Errata and Added Information to
**MC68PM302 Integrated Multiprotocol Processor
 with PCMCIA Interface Reference Manual Rev 1**

February 11, 1997

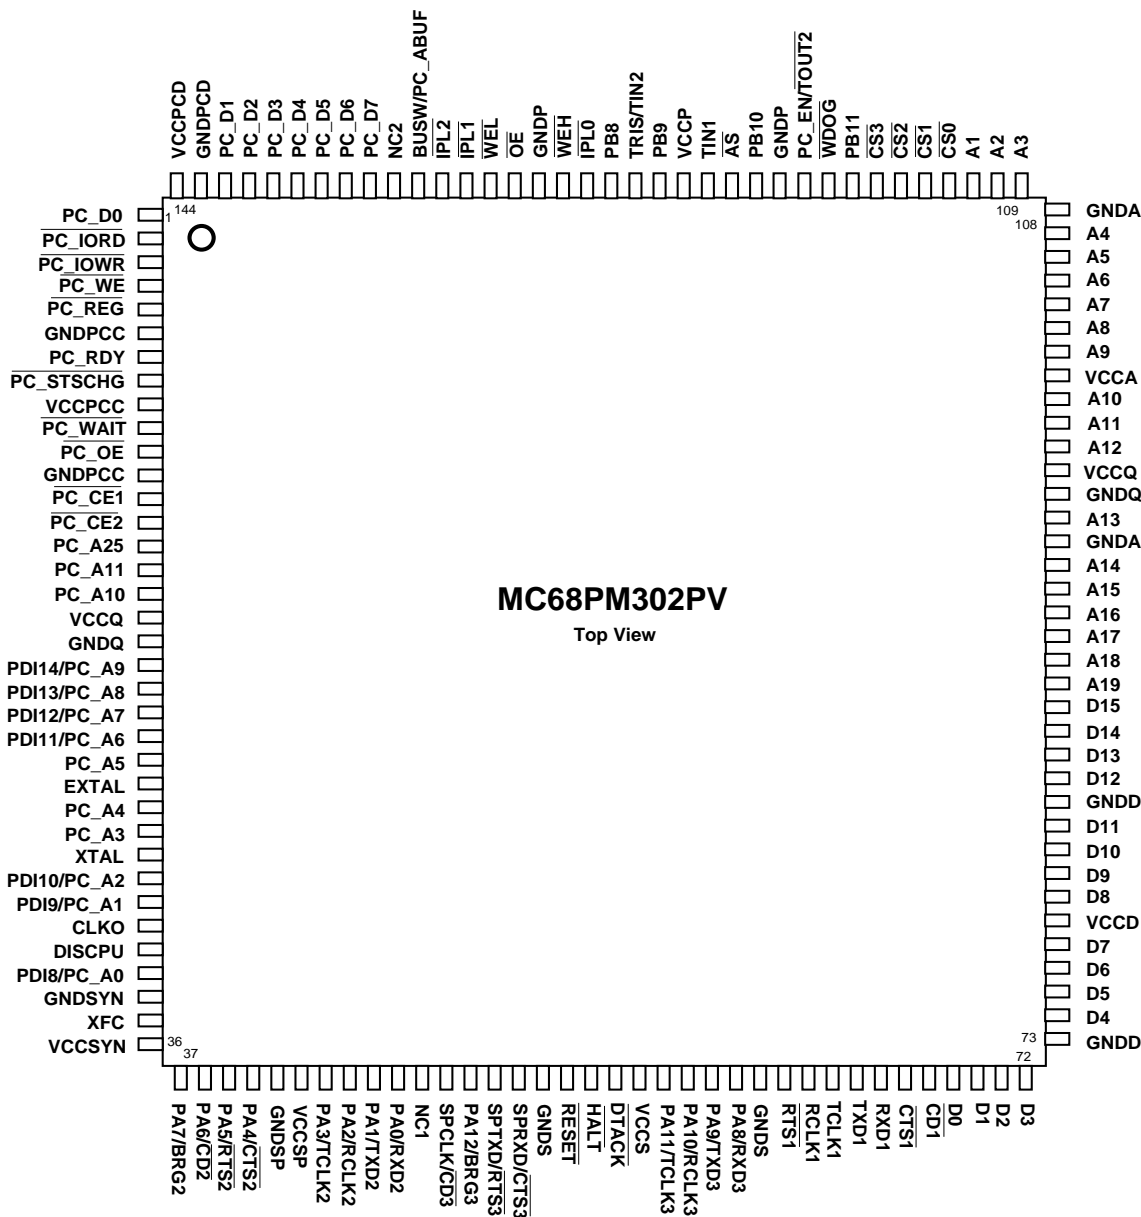
The pin assignment figure for the surface mount (TQFP) package on page 8-2 has two pins mislabeled. The OE and WEL pins are reversed in the figure. The following figure shows the correct pin locations.
